City of Portland, Maine - Building or Use Permit Application

Permit No: 01-0306	Issue Date: APR 13	CBL: 171 B001001
-----------------------	-----------------------	---------------------

BUILDING PERMIT REPORT

DATE: 12 APRIL 2001 ADDRESS: 20 Felicia Lane CBL: 171-3,001
REASON FOR PERMIT: To Construct a 21'6" x 25'4" attached PVI garage
BUILDING OWNER: Patrick T. Johns
PERMIT APPLICANT: _____ CONTRACTOR: Darrell Daas RACIA
USE GROUP: R-3 CONSTRUCTION TYPE: 5B CONSTRUCTION COST: \$15,000.00 PERMIT FEES: \$114.00

ELECTRICAL PLAN

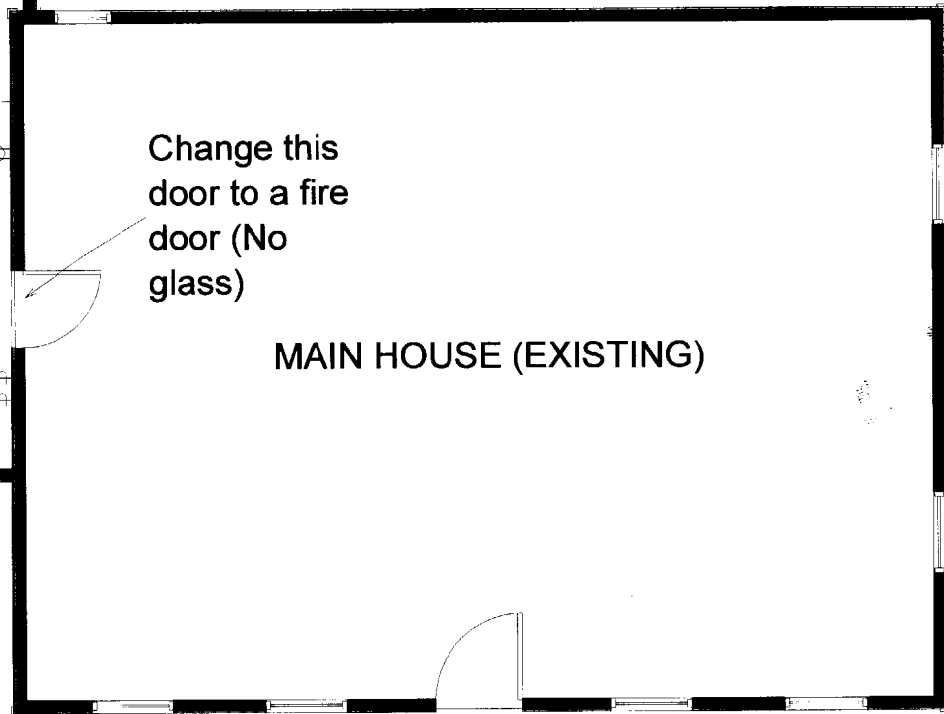
Change this
door to a fire
door (No
glass)
